Well Name: WARREN UNIT	Well Location: T20S / R38E / SEC 28 / SWSE /	County or Parish/State: LEA / NM
Well Number: 129	Type of Well: OIL WELL	Allottee or Tribe Name:
Lease Number: NMLC031695B	Unit or CA Name: WARREN UNIT - GB/SA PA	Unit or CA Number: NMNM71052F
US Well Number: 300253347200S1	Well Status: Producing Oil Well	Operator: APACHE CORPORATION

Sundry ID: 2712231

Type of Action: Plug and Abandonment

**Permanent Abandonment of Federal Wells
Conditions of Approval (LPC Habitat)**

PROPOSED PROCEDURE

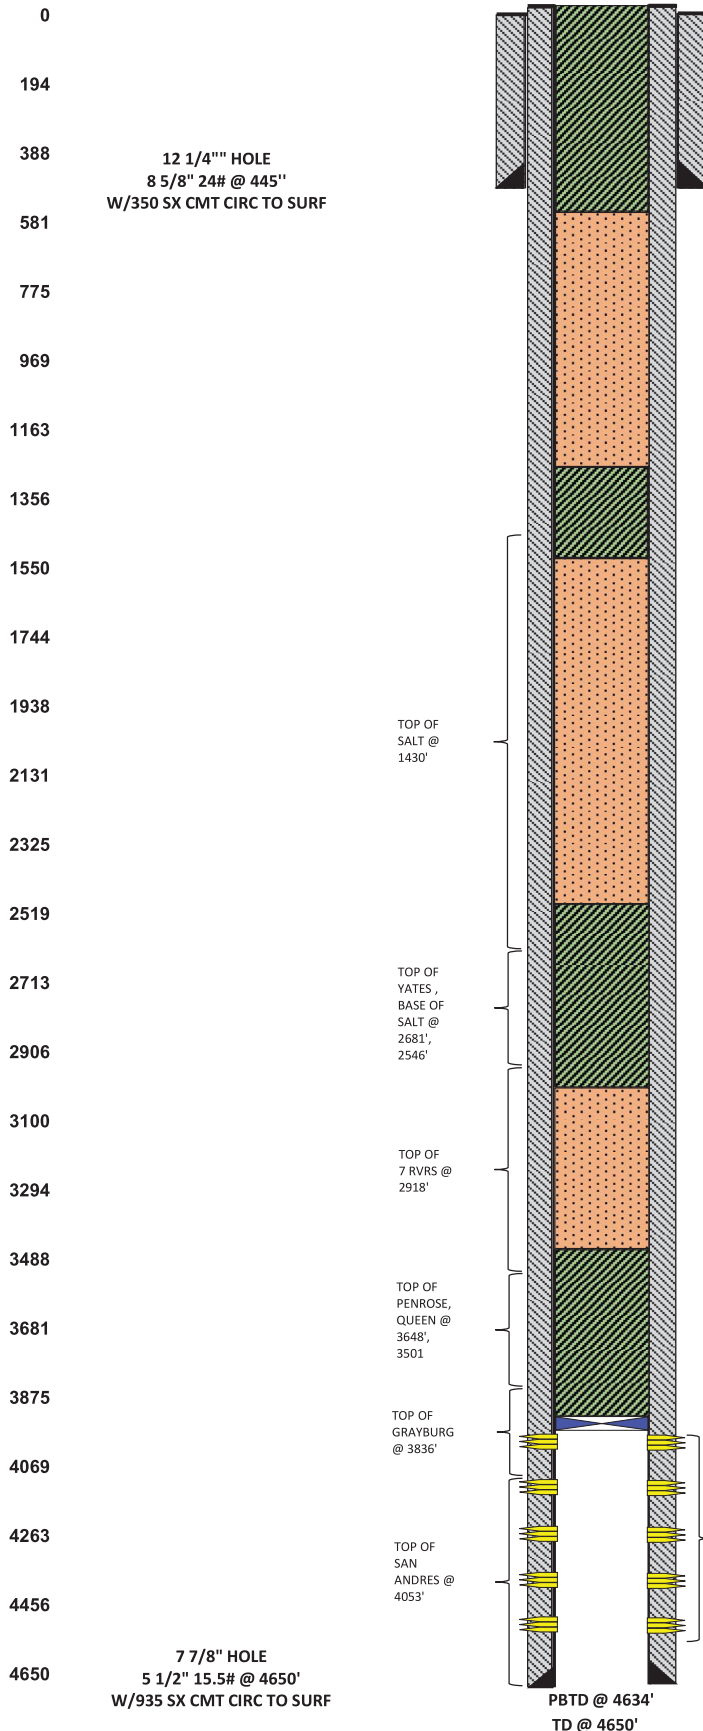
Plug Type	Top	Bottom	Length	Tag	Sacks	Notes
Surface Plug	0.00	495.00	495.00	Verify circulated to surface		
Top of Salt @ 1430	1365.70	1480.00	114.30	WOC and Tag		
Base of Salt @ 2546	2470.54	2596.00	125.46	WOC and Tag	50.00	Same as below
Yates @ 2681	2604.19	2731.00	126.81	WOC and Tag	50.00	
CIBP Plug	3915.00	3950.00	35.00	Verify CIBP depth	25.00	Leak test 500psi, 30mins

No more than 2000' is to be allowed between plugs in open hole, and no more than 3000' between plugs in cased hole.

R111P: Solid plug in all annuli - 50' from bottom of salt to surface.
